**CITY OF FRANKLIN****REPORT TO THE PLAN COMMISSION****Meeting of November 21, 2019****Special Use and Site Plan Amendment**

Project Name:	The Learning Experience Special Use and Site Plan Amendment
Project Address:	7760 Lovers Lane Road
Applicant:	Gary Wendt, Bradford Franklin LLC
Property Owner:	Franklin-Wyndham, LLC
Current Zoning:	CC City Civic Center District
2025 Comprehensive Plan	Mixed Use
Use of Surrounding Properties:	Single-family residential to the north, stormwater detention pond to the south, Risen Savior Lutheran Church to the east and Summit Credit Union to the west
Applicant Action Requested:	Recommendation of approval for the proposed Special Use and associated Site Plan for the development of The Learning Center daycare facility.

PROPOSED LOT 4 SITE LSR

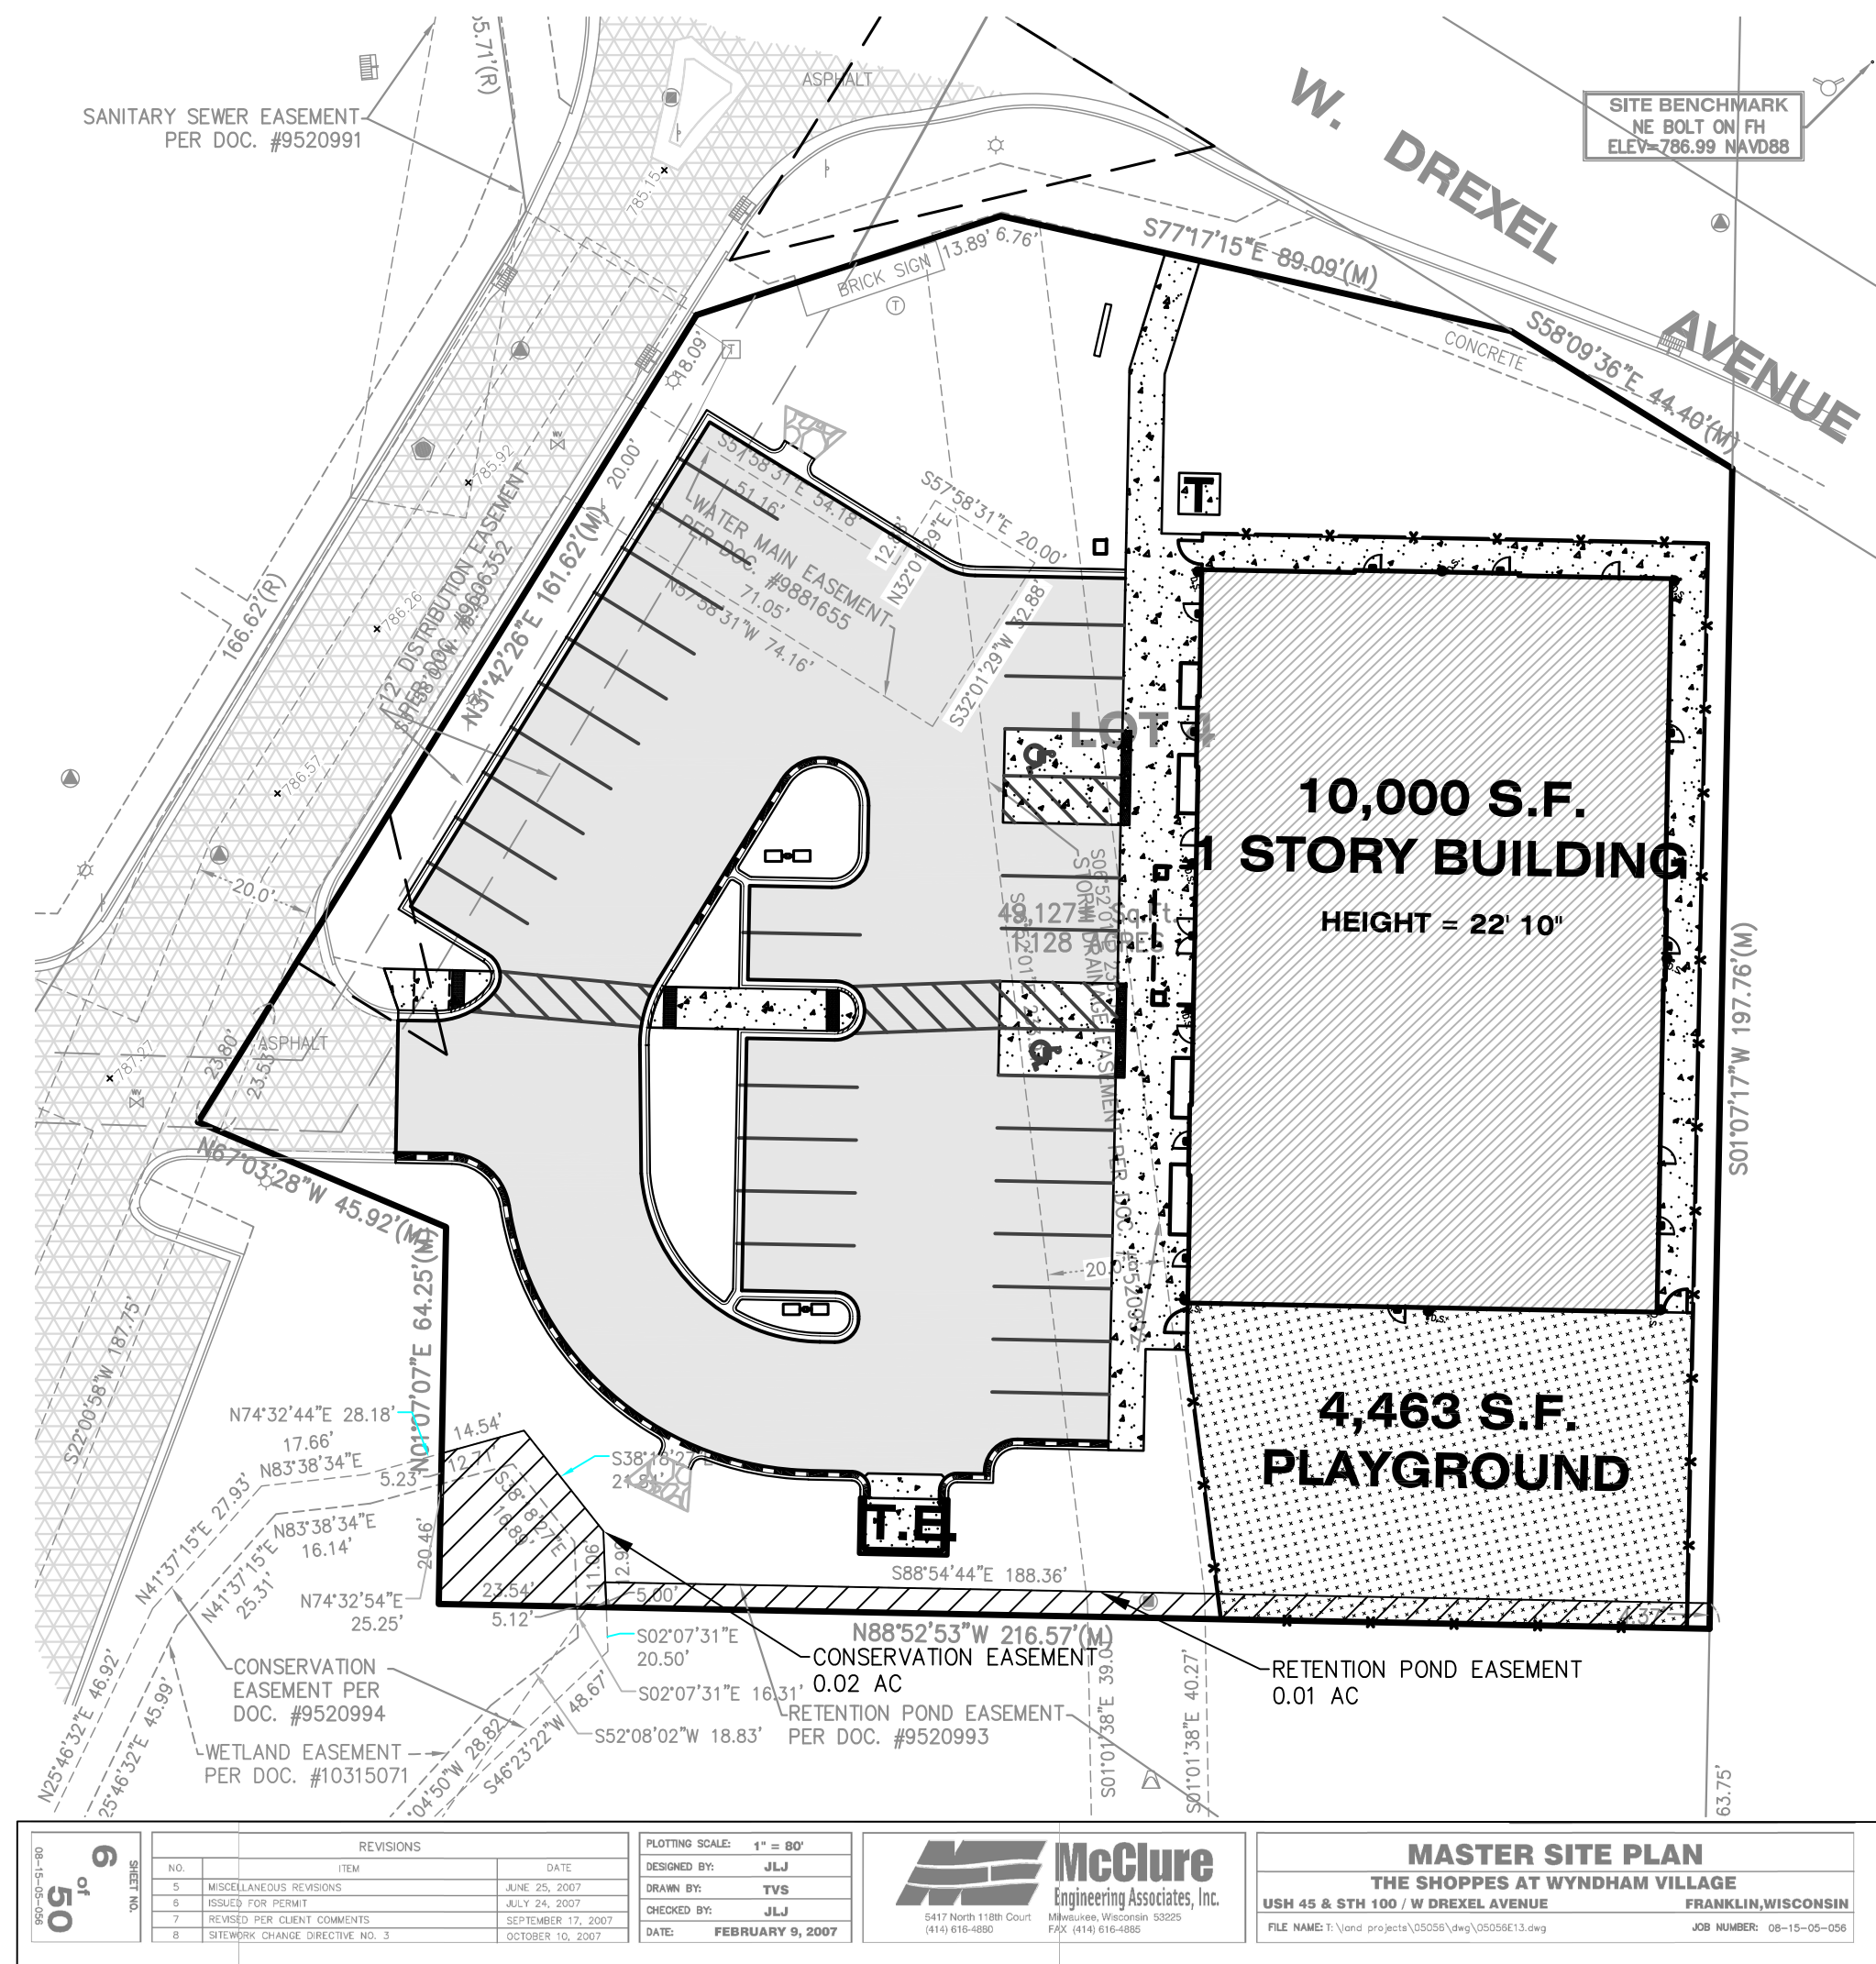
Comment 3: Please include additional site data, such as square footage of proposed impervious surface, greenspace and Landscape Surface Ratio (see definitions below).
Landscape Surface Ratio (LSR). The ratio derived by dividing the area of landscaped surface by the base site area.

Response 2a: These calculations are shown on the Wyndham Village LSR exhibit and the NRPP. The area of the approved Wyndham Village impervious area for Lot 4 (the area of The Learning Experience project) was examined. A comparison of the approved LSR for this area and the Proposed TLE project has been provided. (In the meeting with staff it was discussed that an aerial photograph analysis be performed. However, there are several vacant lots within the subdivision which precluded this method of analysis.)

Response 3: These areas are Shown on the Site Plan, the NRPP and the Wyndham Village LSR Exhibit.
